VKBD 1015

Technical Bulletin - October 2013

RENAULT Clio Grandtour, Clio III, Megane II, Modus/Grand Modus, Twingo

Fitting Instructions: mandatory replacement of the nut included in the kit!

VKBD 1015

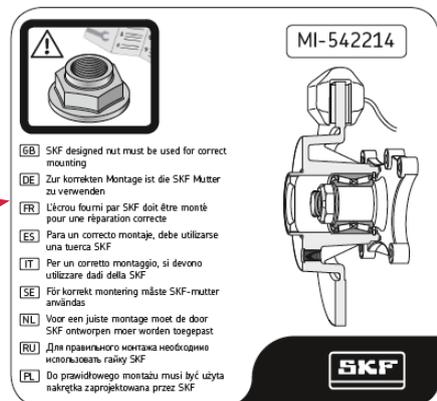
To ensure a complete and professional repair of the wheel bearing and brake disc kit VKBD 1015, the nut provided in the kit must be changed during the mounting.

The correct nut tightening torque must be applied (175 Nm) in order to get the required clamping force needed by the bearing unit.

SKF nut design evolution

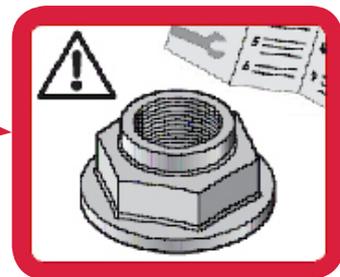
It emphasizes the importance of throwing the old dismantled nut away and use the nut included in the box.

Note: if the dismantled/old nut is re-used, performances issues or early failure can occur!

Old nut design

New nut design

Tightening torque: 175 Nm
